DOCKETED	
Docket Number:	23-AFC-02
Project Title:	Elmore North Geothermal Project (ENGP)
TN #:	253669
Document Title:	Elmore North Geothermal Project Report of Waste Discharge and Detection Monitoring Plan Update
Description:	N/A
Filer:	Lindsey Xayachack
Organization:	Jacobs
Submitter Role:	Applicant Consultant
Submission Date:	12/19/2023 12:23:20 PM
Docketed Date:	12/19/2023

RE: Report of Waste Discharge and Application for Elmore North Geothermal Project – December 2023 Update to ROWD Application Package

Changes to ENGP since the last application package submitted to Colorado River Basin RWQCB May 24, 2023, are described in the list below. Additionally, updated ROWDs and Detection Monitoring Plan (DMP) are submitted with redline to emphasize changes.

Report of Waste Discharge for Elmore North Geothermal Power Project

Figure 3
General Arrangement,
Elmore North Geothermal Project
Imperial County, California

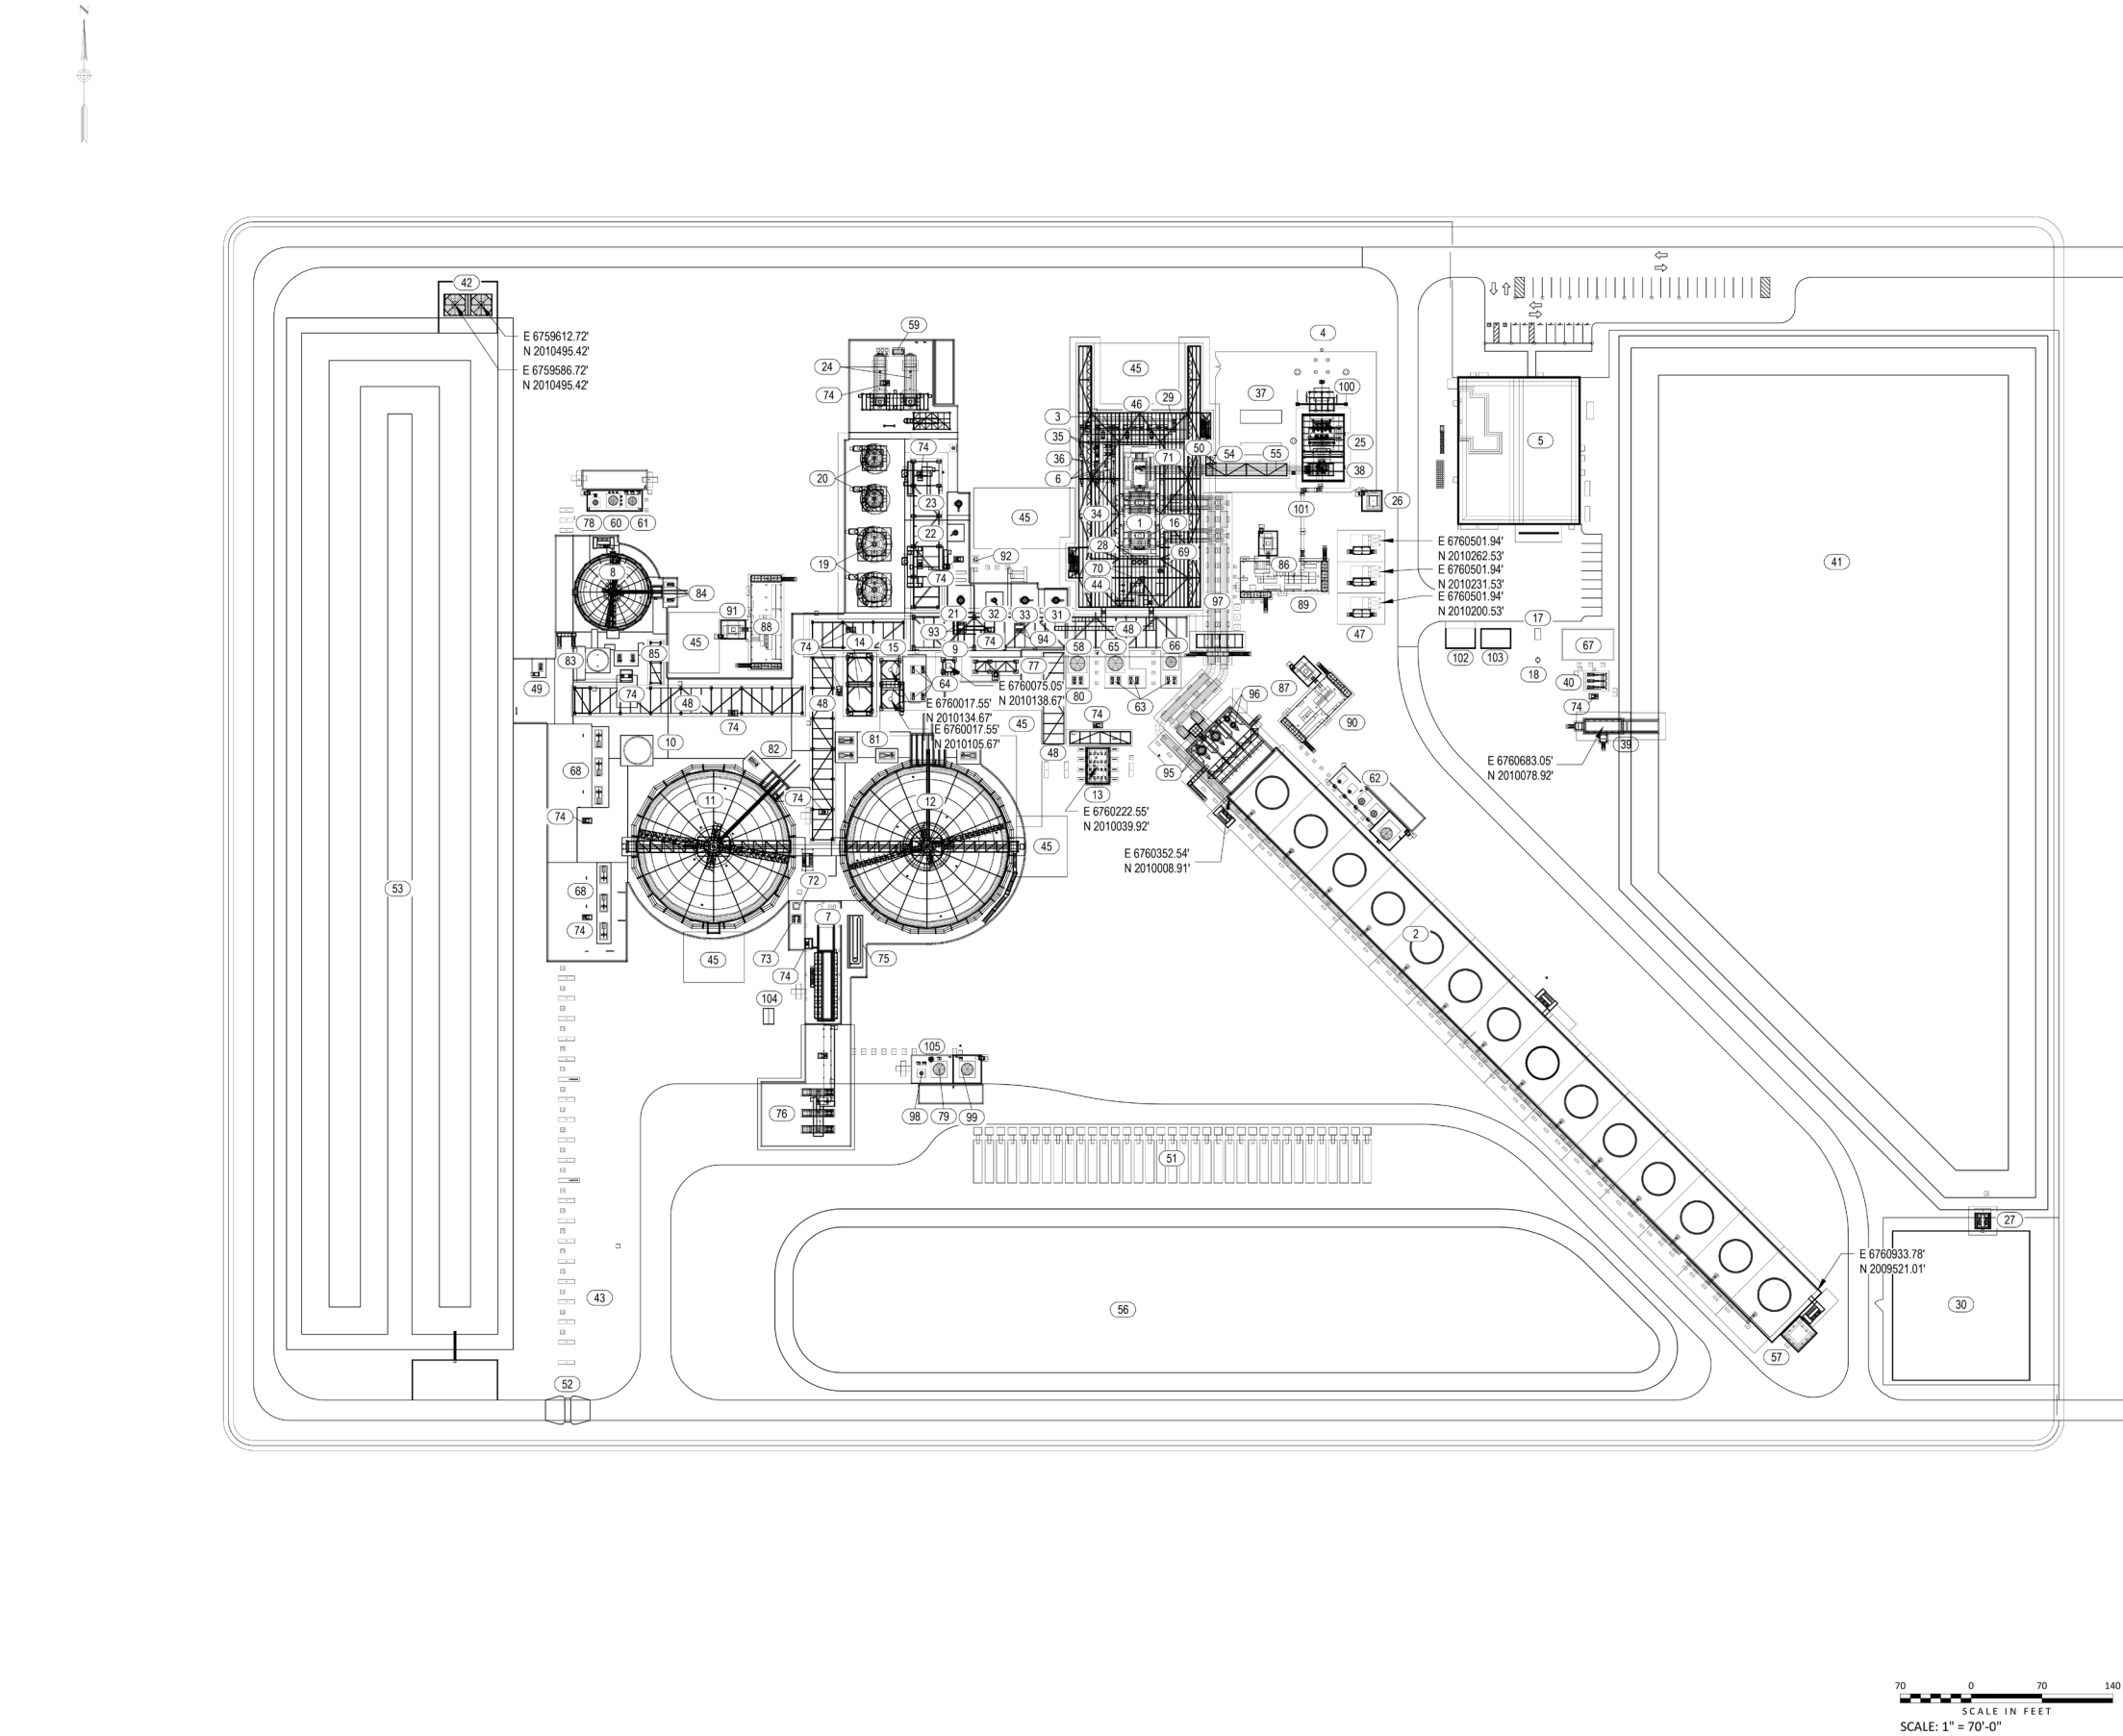
- Stormwater retention basin relocated to the south side of the proposed project site.
- Overall project site grading and drainage altered to guide site runoff towards new drainage inlet locations and new stormwater retention basin.
- Project site infrastructure general arrangement refinements.
